Design Change Reevaluation Form

FPID 442764-1, Suncoast Parkway 2

MEMORANDUM

SUBJECT: *Design Change Re-evaluation – Change to Local Roads Design*
Suncoast 2
Financial Project ID: 442764-1-52-01
County / Section No.: Citrus / 02 470 000
State Road Number: SR 589
Project Description: From SR 44 to CR 486

Suncoast Parkway 2 Change in Local Roads

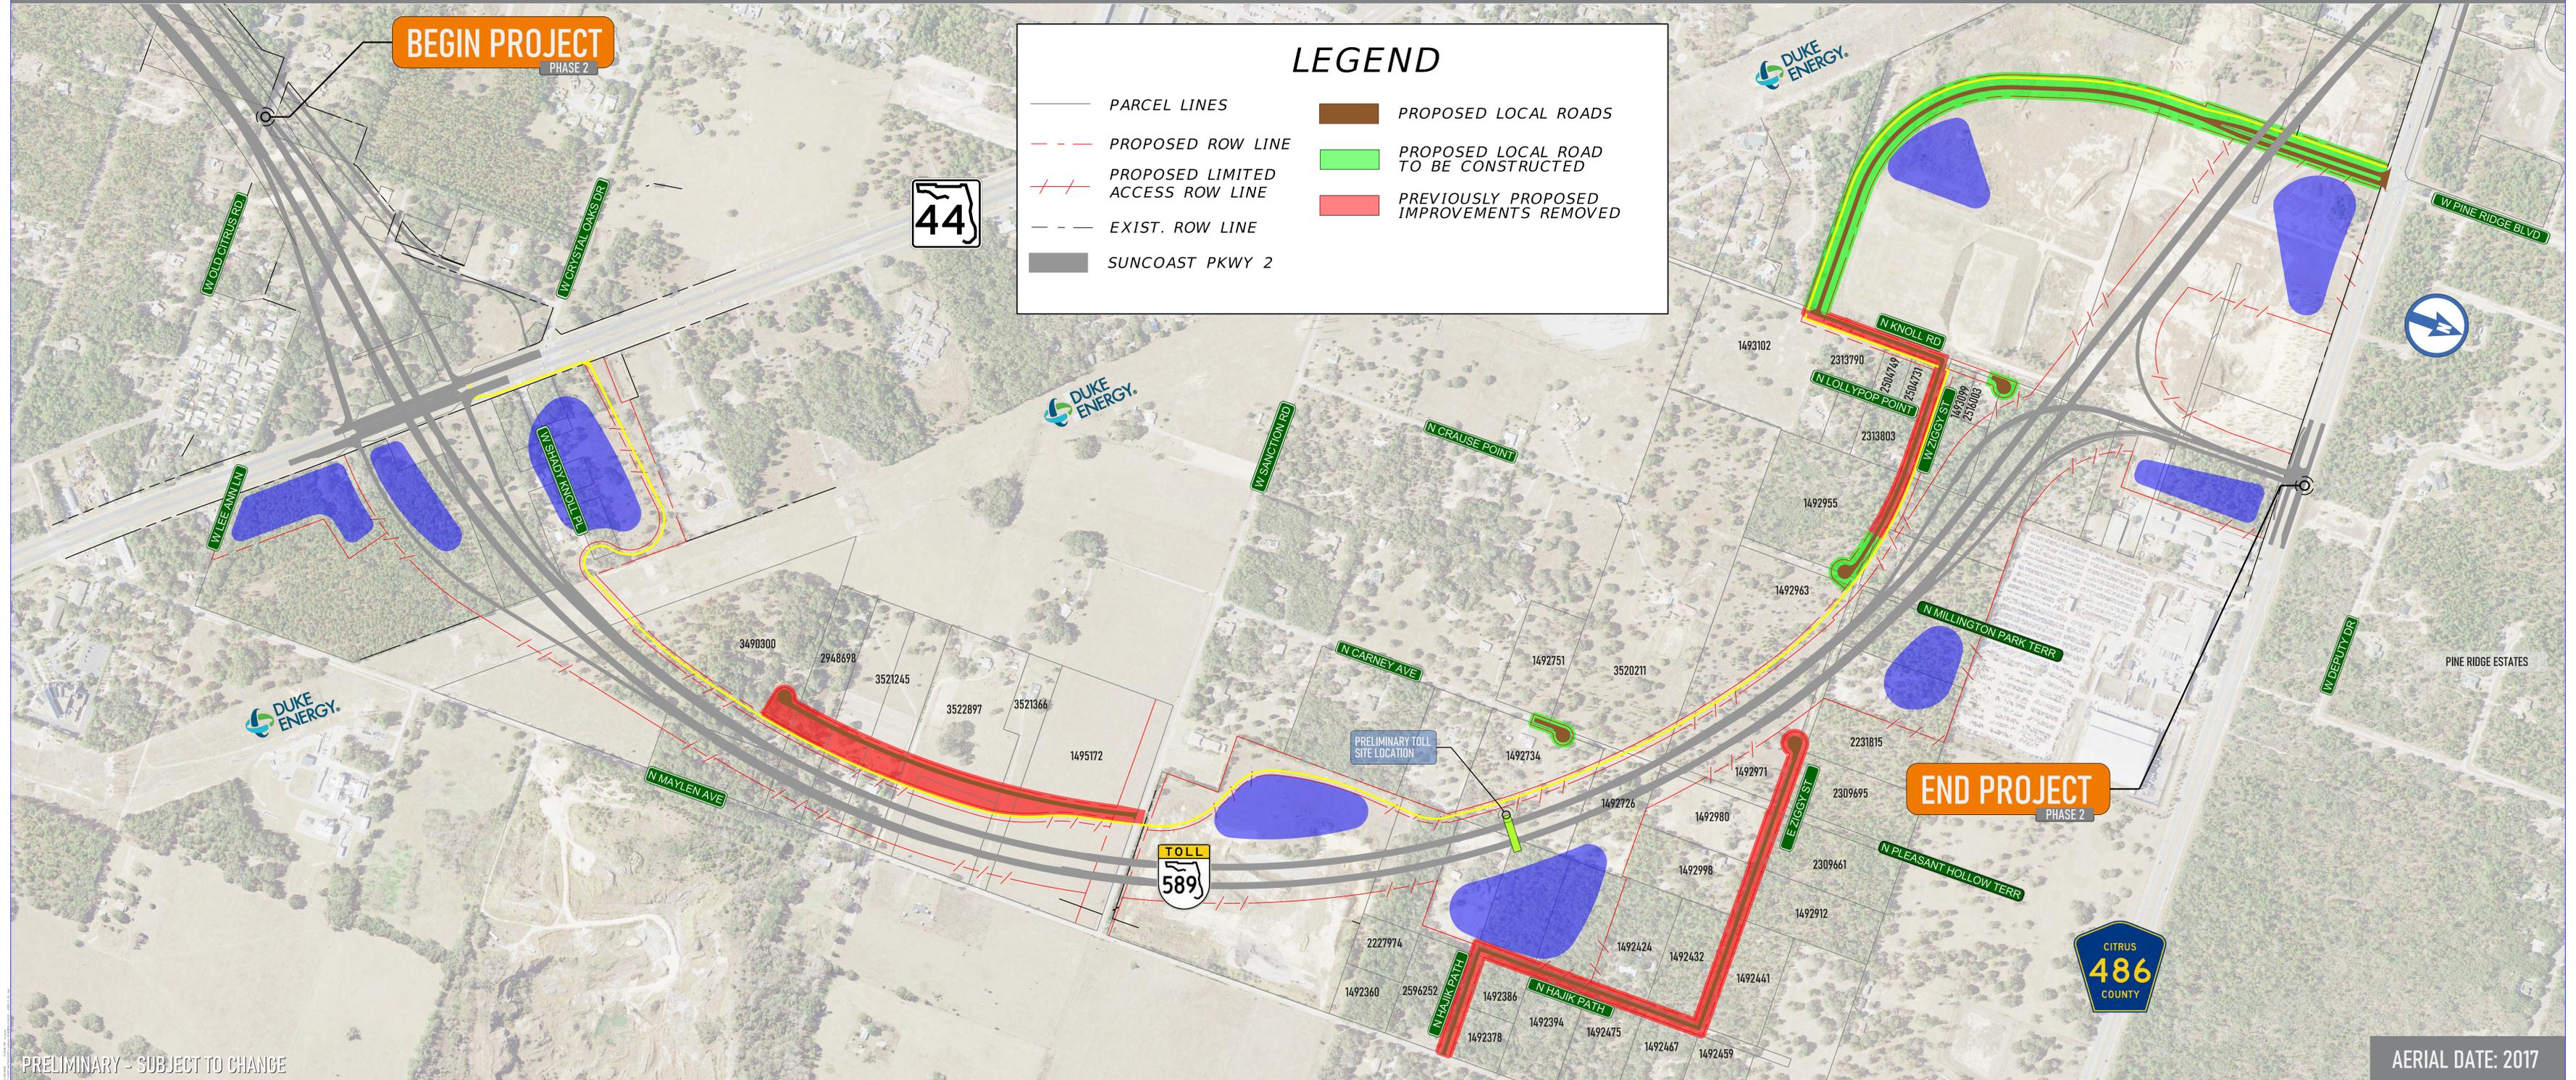
1. South of West Sanction Road: The new unnamed road and new cul-de-sac south of Sanction Road will be removed, (red hatch).
2. East Ziggy Street and North Hajik Path:
 - a. The connection between North Hajik Path and East Ziggy Street, and associated improvements to North Hajik Path and East Ziggy Street will be removed (red hatch).
3. West Ziggy Street and North Knoll Road:
 - a. The West Ziggy Street and North Knoll Road improvements will be removed (red hatch). New cul-de-sacs will remain at the end of each road (green hatch).

Re-evaluation: Update graphic to show changes for local roads. Update “Access Roads Modification” table. No changes in impact to resources/issues.
